Value Analysis/Value Planning Study

Detroit River International Crossing DRIC

February 2, 2007

Interchange VP1

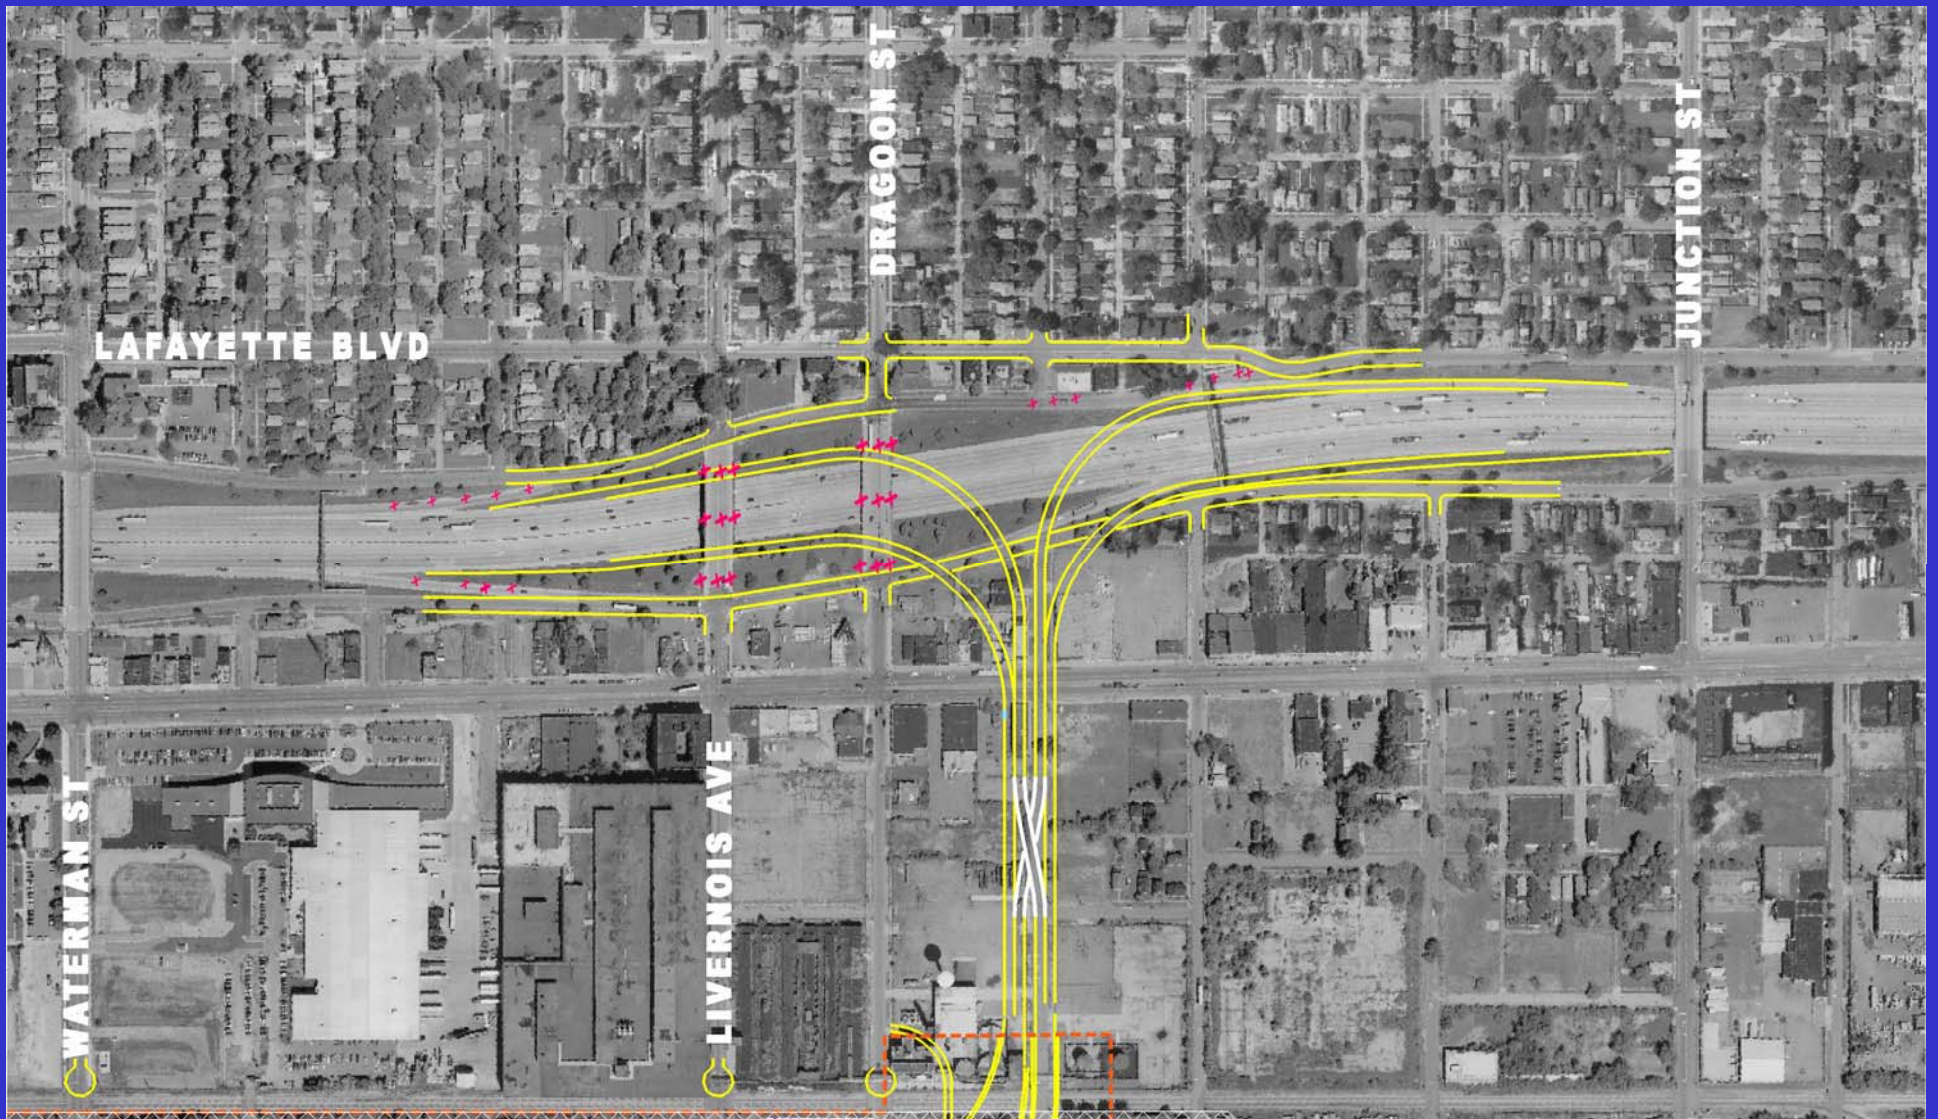
- **Advantages:**
 - Maintain Clark and Springwells Interchanges.
 - Localizes impacts to Service Drives.
 - Requires less ROW.
 - Reduces impacts North of I-75.
- **Disadvantages:**
 - Design speed 30 MPH in circle.
 - Close Livernois bridge.
 - Closes Livernois/Dragoon Interchange.
 - Impacts 64 unit Building.
